## **NOTICE OF A TYPE II DECISION ON A PROPOSAL IN YOUR NEIGHBORHOOD**

### **CASE FILE NUMBER: LU 08-127983 AD**

**Site Address:** 9310 SW 8TH DR

**Case Type:** AD (Adjustment Review)  
**Procedure:** Type II, administrative decision with appeal to Adjustment Committee.

SOUTH ELEVATION (SIDE)

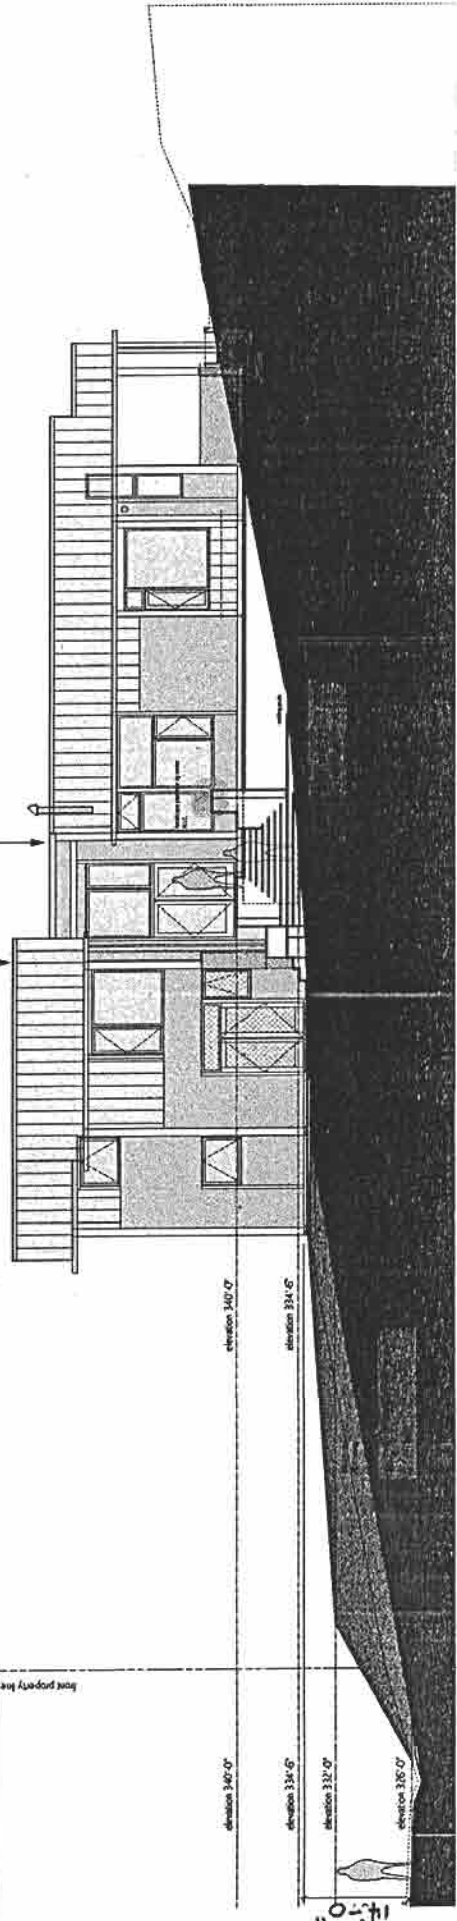
However, the owner desires to revise the main entrance location. The revised main entrance location is proposed to be on the south elevation, to the east of and behind a portion of the residence that faces the street. The main entrance location is proposed to be approximately 14 feet east of the residence's longest street-facing wall, and oriented at 90 degrees from the street. (Please see the attached site plan and elevations for a graphic depiction of the proposed main entrance location).

- These proposed features (the orientation and articulation of the stairs, the pedestrian pathway vertical element with street number, and the plantings on the east side of the pathway and north of the vertical element) will ensure that the location of the pedestrian entrance is clearly identifiable from the street by its articulation, and will ensure that pedestrians can easily find the main entrance.

The stairs have been designed and articulated for expanded visual significance. The design of the pedestrian pathway includes a prominent vertical element that displays the street number for the house. The position and orientation of this element both indicates a direction for pedestrian travel, and a distinct way-finding link along the pathway to the main entry doors. A group of landscape plantings parallel to the path direction are also illustrated on the site plan and elevation. The plantings are located on the east side of the north-south oriented portion of the pedestrian pathway to the main entrance.

- A. The plans submittal for the building permit (08-110002 RS) must be revised to reflect the following:
- 1) The information and design approved by this land use review as indicated in Exhibits C.1 through C.3, which includes:
    - a) The design and articulation of the pedestrian pathway and the stairs leading to the main entrance;
    - b) The prominent vertical element at the south end of the stairs that displays the street number for the house; and,
    - c) The group of landscape plantings located on the east side of the north-south oriented portion of the pedestrian pathway to the main entrance.

- 2) The plans must indicate that the pedestrian pathway and stairs will differ from the vehicle driveway and parking pads in terms of one or more of the following: surface material, surface texture, and/or surface color.
